Instrument Panel Trim Reflection

Service Category Vehicle Interior

REVISION NOTICE

December 14, 2020 Rev1:

Figure 1. Brushed Aluminum Trim

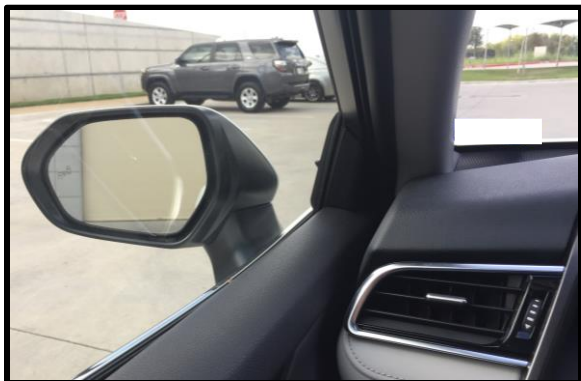
Some 2018 – 2020 model year Camry and Camry Hybrid vehicles with brushed aluminum or gray metallic trim may exhibit a condition where the instrument panel LH and RH outside register assemblies reflect upon the side window glass.

Below are some examples of this condition. Alternative outside register assemblies with a gloss black finish have been developed to reduce this condition. Follow the Repair Procedure in this bulletin to reduce this condition.
